SERVICE BULLETIN

N° **139-677**

ATA 23 - 150 FT AURAL INHIBIT KIT P/N 4G2350F01511, INSTALLATION OF

Through the installation of kit P/N 4G2350F01511 this Service Bulletin gives the operators of AW139 helicopters the option to add a new white STATUS Message “150 FT AURAL INHIB” in the CAS list of MFDs.

Figure 1

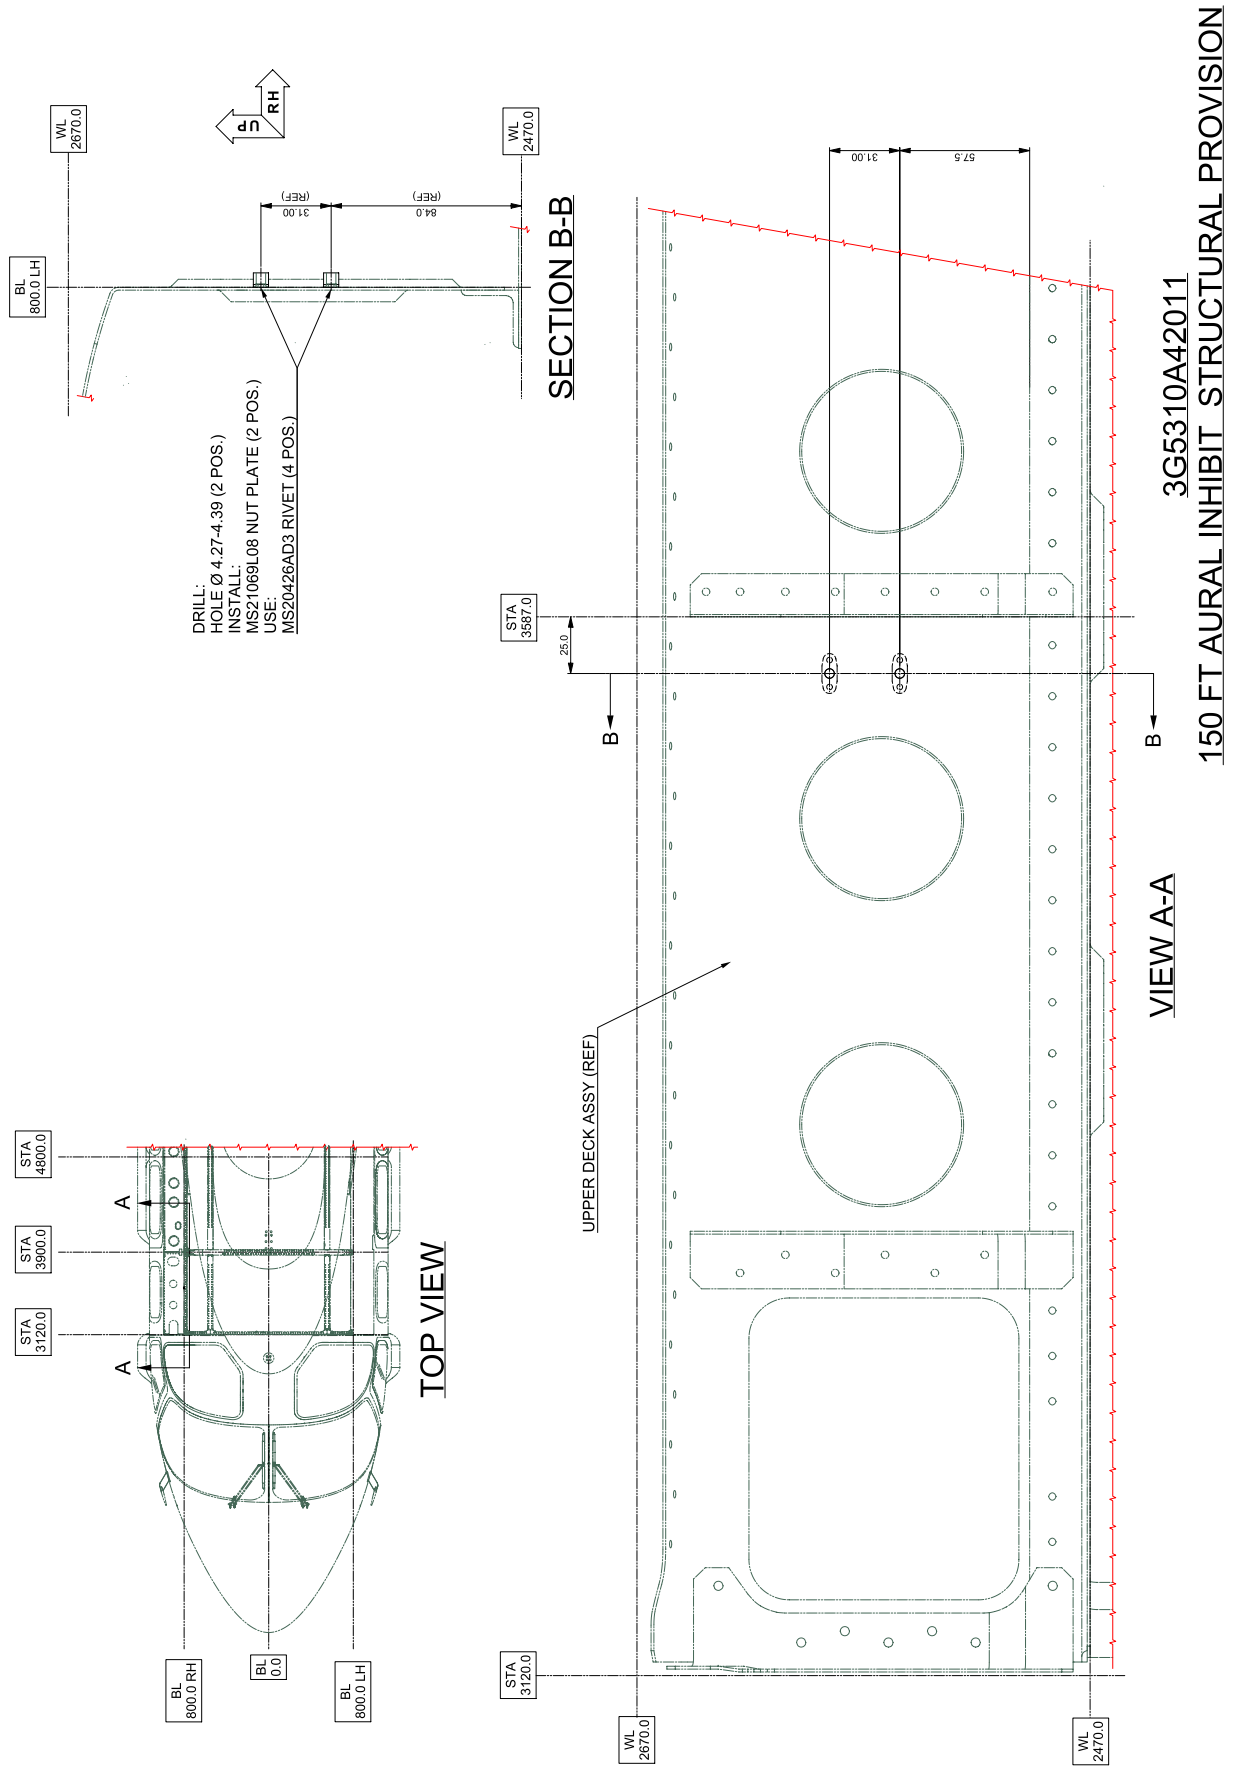
7. With reference to Figure 1 install the 150 ft Aural Inhibit structural provision P/N 3G5310A42011, as follows:
 - 7.1 With reference to Figure 1 View A-A, mark position of two nut plates to be installed on upper deck.

- 7.2 With reference to Figure a View A-A drill n°2 holes Ø 4.27 to 4.39 mm diameter at marked positions and install n°2 nut plates P/N MS21069L08 using n°4 rivets P/N MS20426AD4-3.

Figure 3

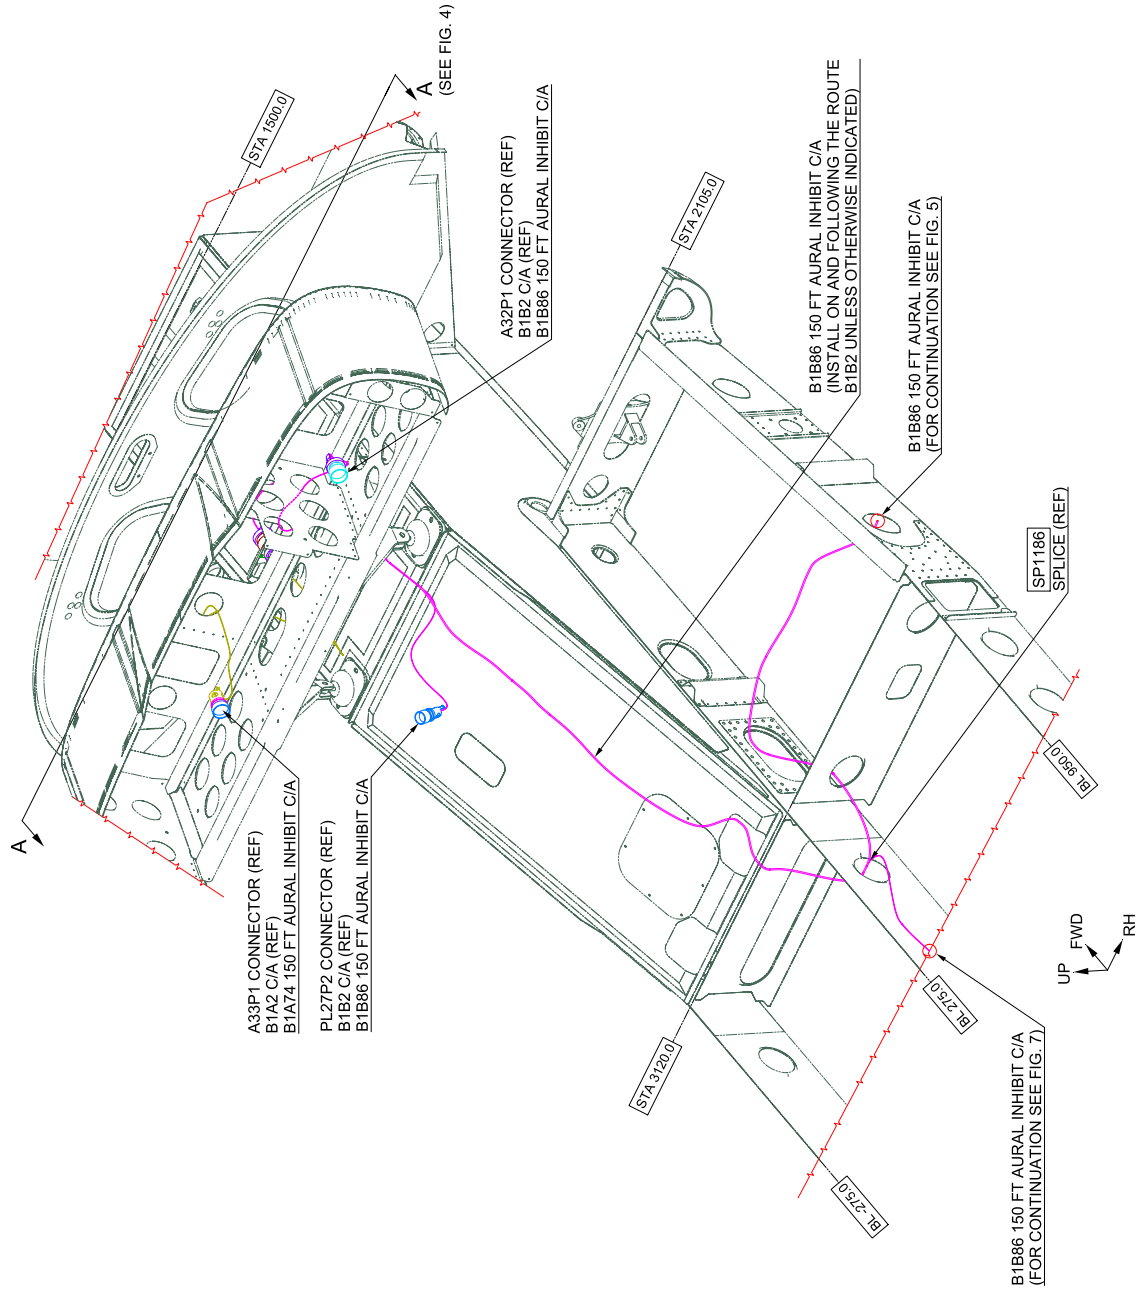
- 8.2 With reference to Figure 3, Figure 7 and Figure 15 Wiring Diagram disconnect wire R199A22N of route B1B2, laid down between PL27P2 connector of the Miscellaneous Control panel in the interseat console and P108 sectioning connector in cabin floor. Remove wire R199A22N or stow it in adjacent area.

- 8.7 With reference to Figure 3, Figure 15 wiring diagram and table on Figure 17 make the electrical connections at A32P1 and A33P1 connectors of the Pilot's MFD and Copilot's MFD, at J16 connector behind the Instrument panel and at PL27P2 connector of the Miscellaneous Control panel.

Figure 4

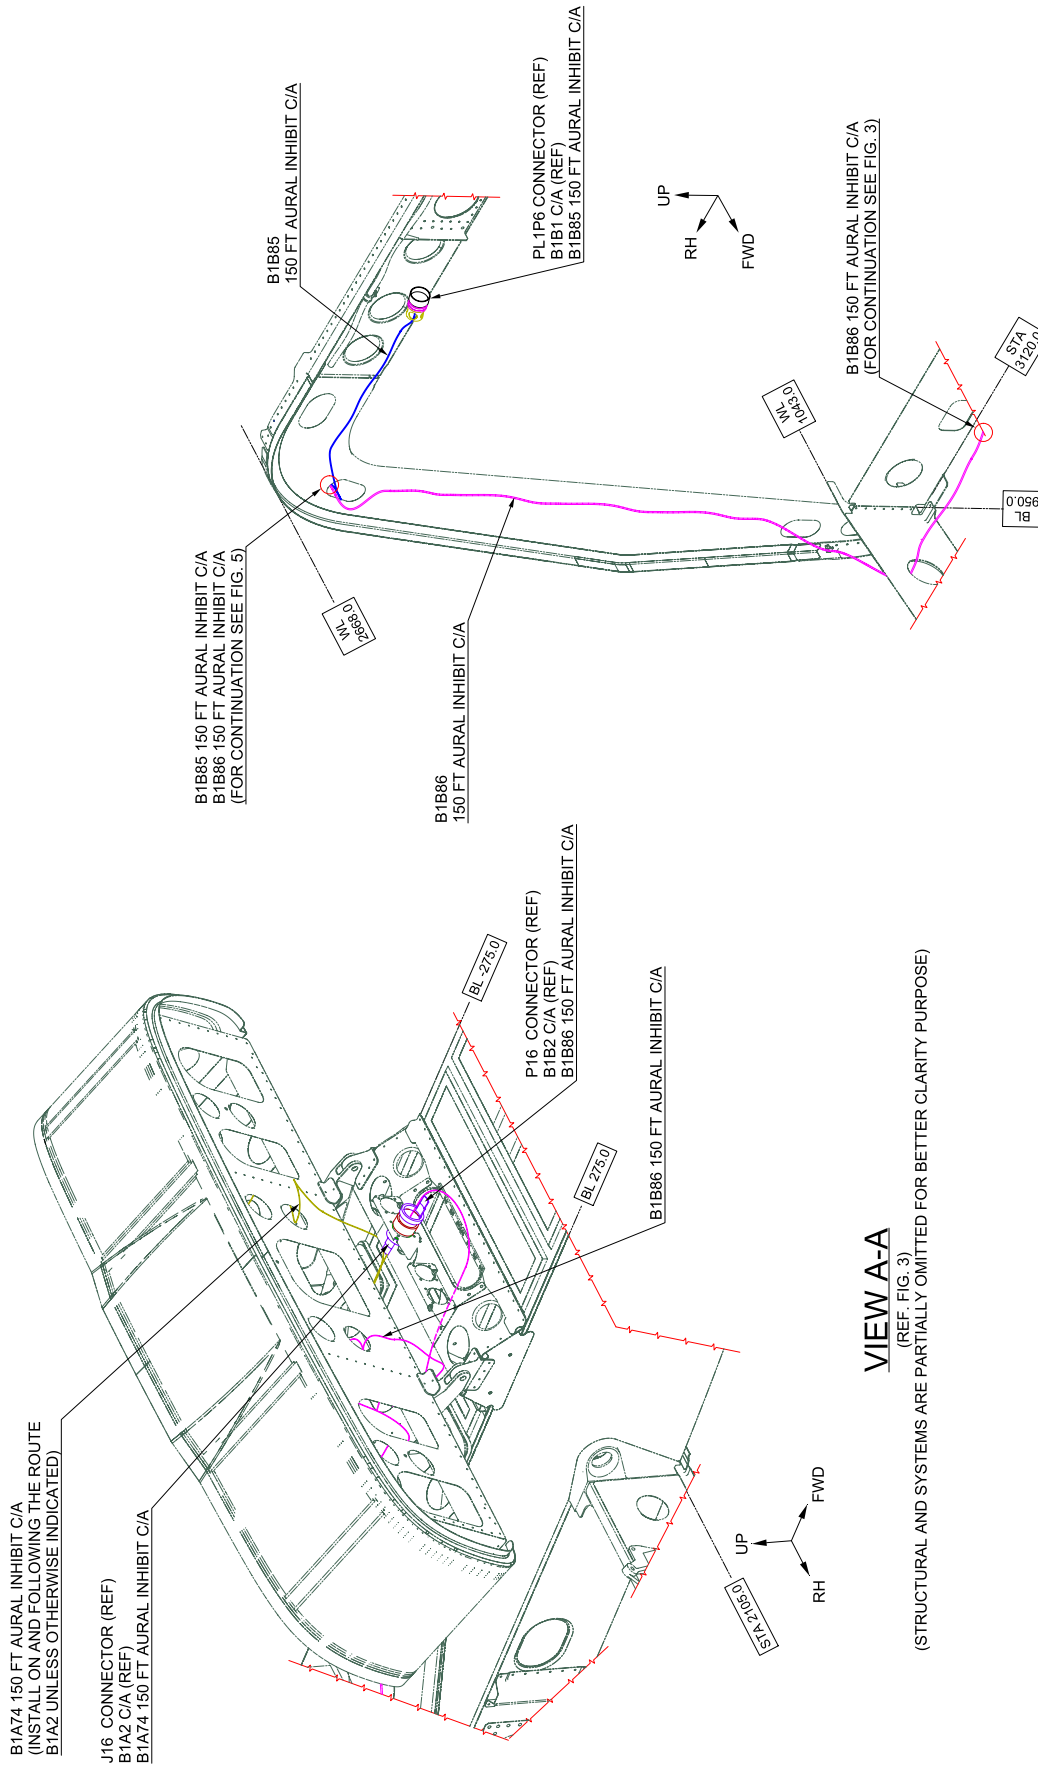
- 8.11 With reference to Figure 4, Figure 15 wiring diagram and table on Figure 17 make the electrical connections at PL1P6 connector of the Circuit Breaker panel.

Figure 5

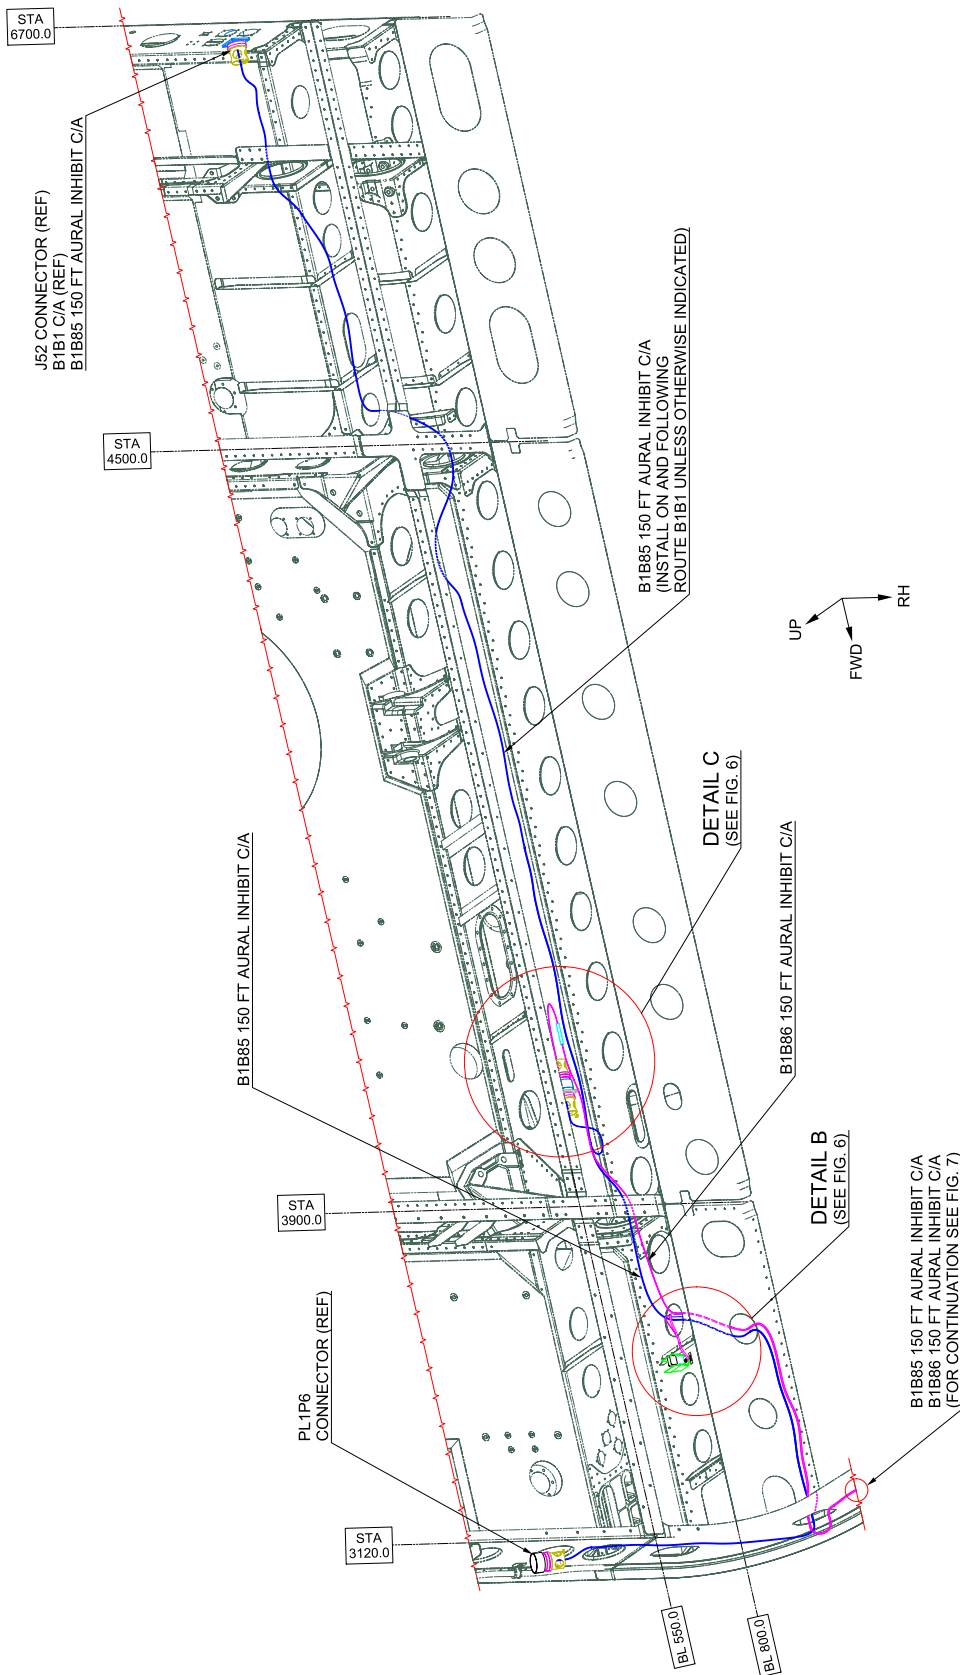
- 8.1 With reference to Figure 5 and Figure 15 Wiring Diagram disconnect wire F100A20-G, of route B1B161, laid down between PL1P6 connector of the Circuit Breaker panel and J52 sectioning connector in cabin roof. Remove wire F100A20-G or stow it in adjacent area.

Figure 6

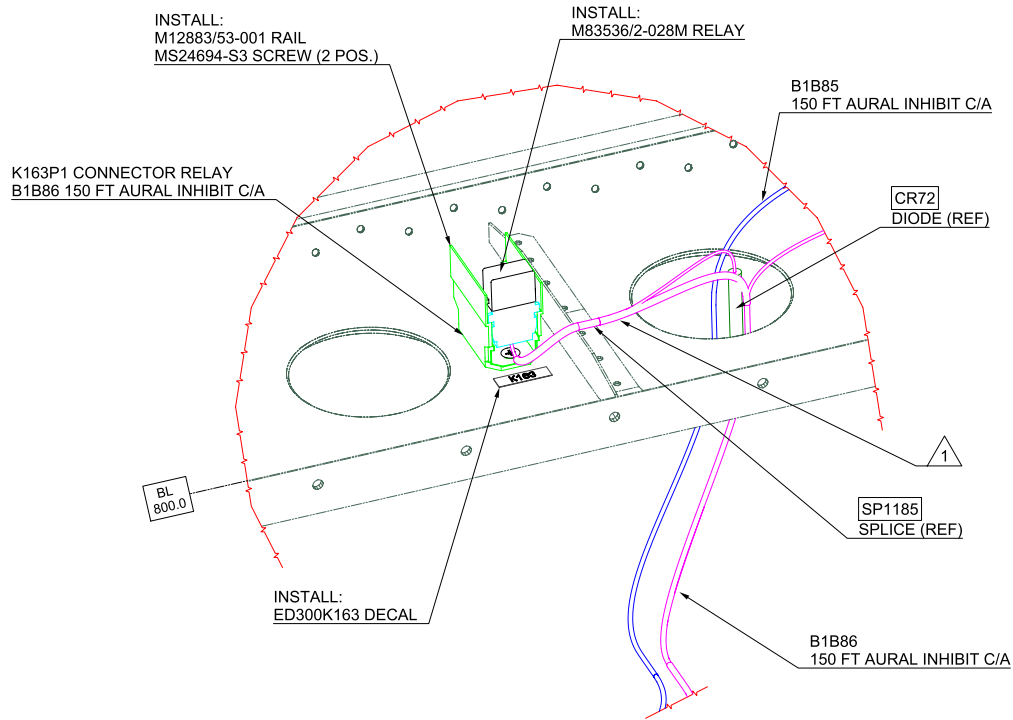
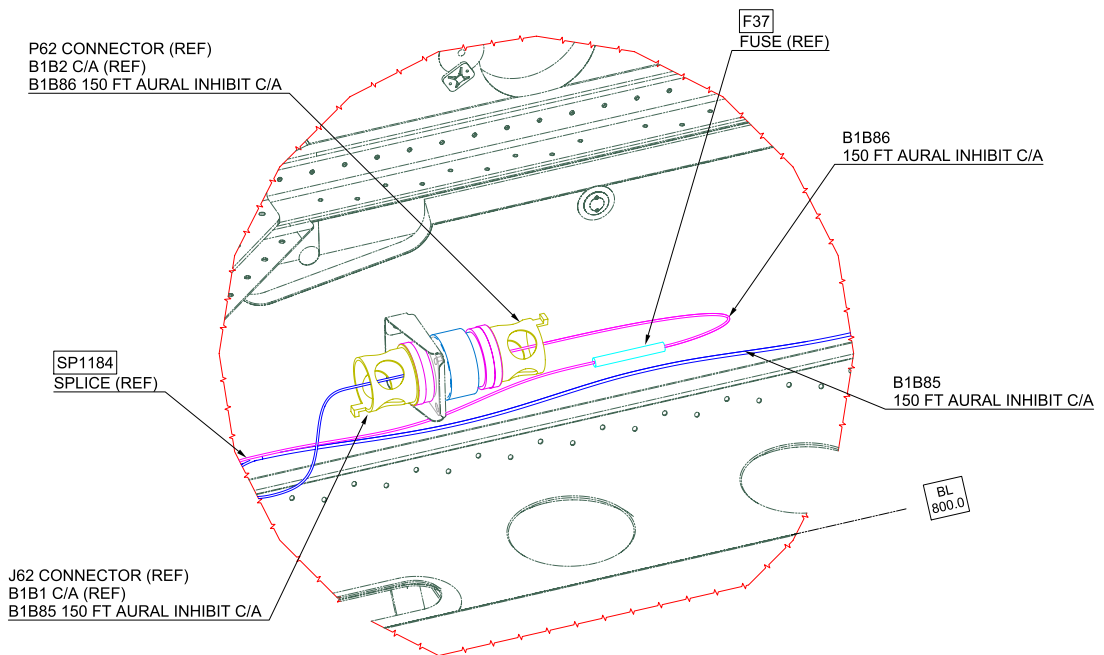
- 8.3 With reference to Figure 6 Detail B, install one rail P/N M12883/53-001 with n°2 screws P/N MS24694-S3, on the RH upper deck beam.
 - 8.4 With reference to Figure 6 Detail B, install one relay P/N M83536/2-028M (K163P1) into rail.

- 8.8 With reference to Figure 6 Detail B, Figure 15 wiring diagram and table on Figure 17 make the electrical connections at K163P1 connector of Relay K163. Make sure to protect with Nomex sleeve P/N A582A05 the wire crossing over the existing angle, as shown in Detail B.

- 8.9 With reference to Figure 6 Detail C, Figure 15 wiring diagram and table on Figure 17 make the electrical connections at J62 and P62 sectioning connectors and at J52 P52 connectors on RH upper deck beam.

△ - CABLE ASSEMBLY TO BE COVERED WITH A582A05 NOMEX FOR DISTANCE AS SHOWN (140 mm).

Figure 7

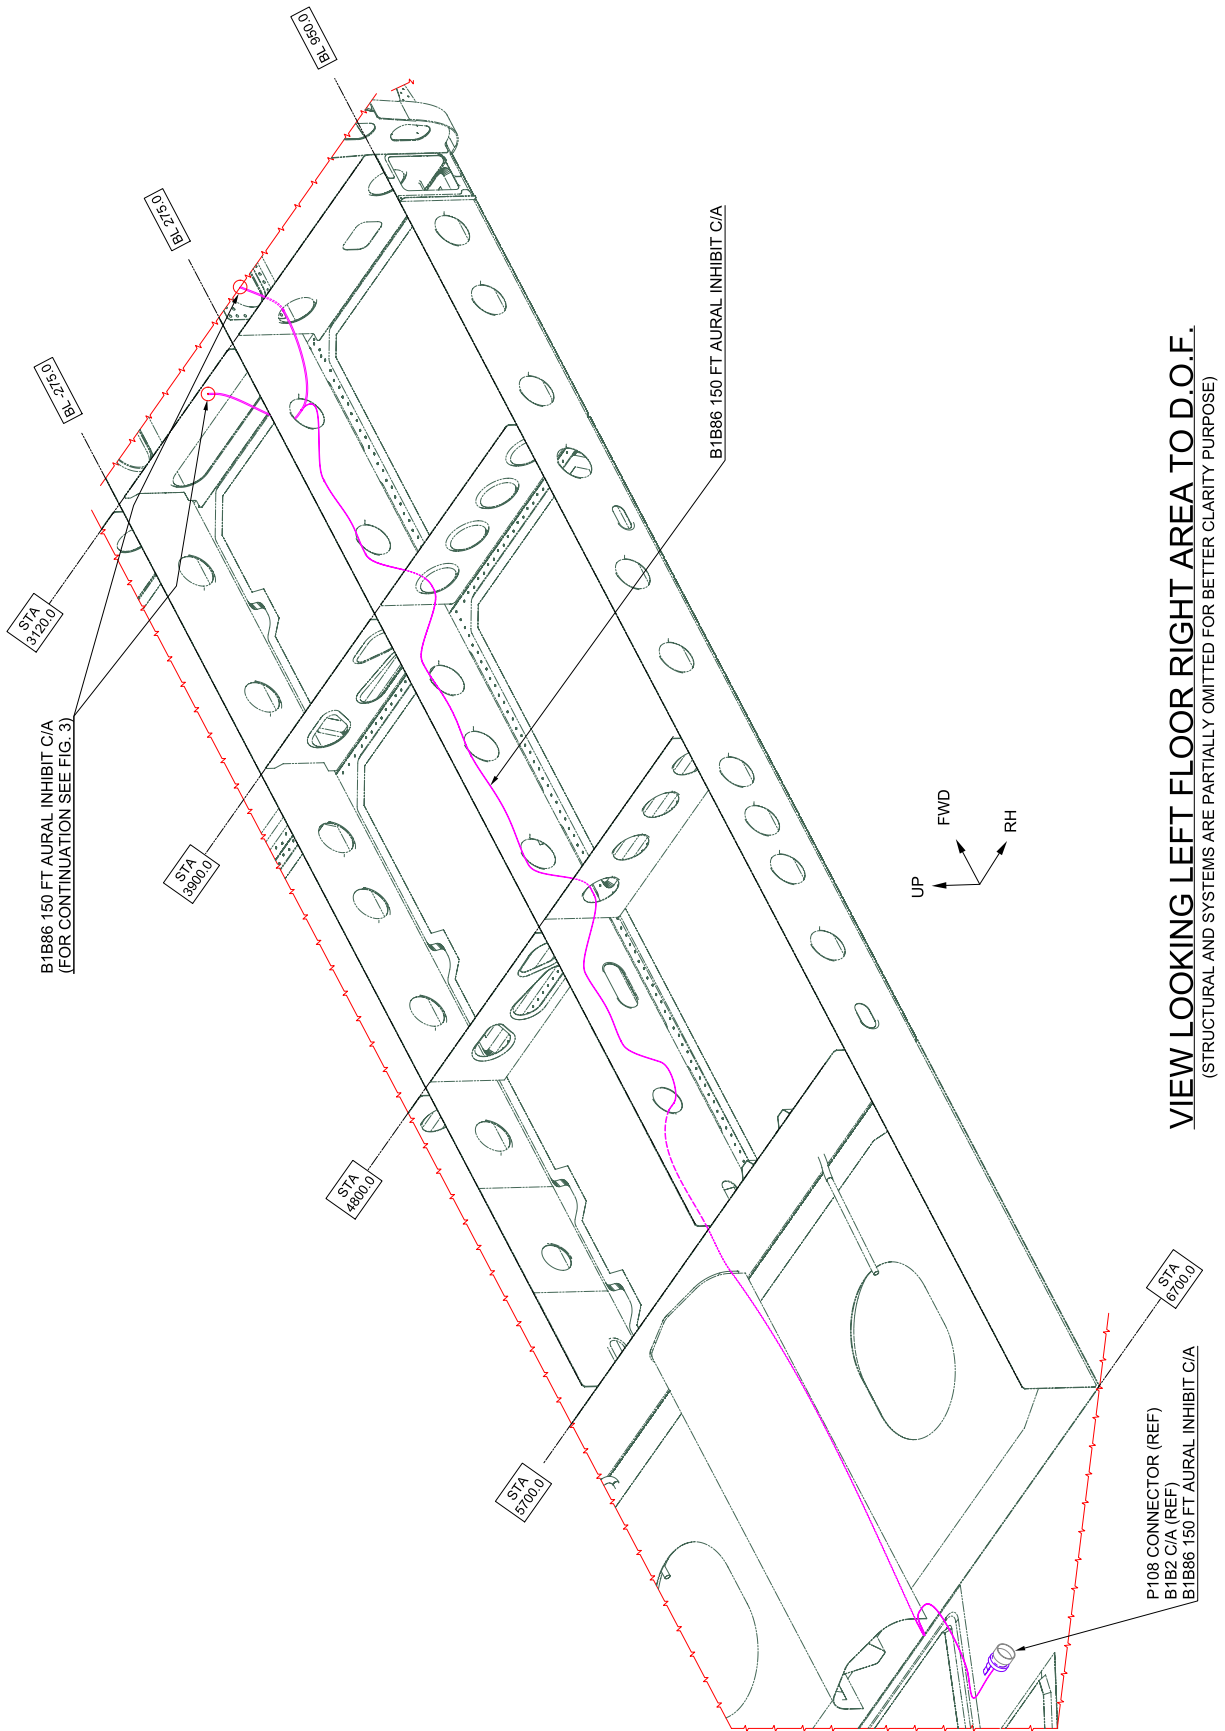
- 8.10 With reference to Figure 7, Figure 15 wiring diagram and table on Figure 17 make the electrical connections at P108 sectioning connector on rear fuselage bottom floor.
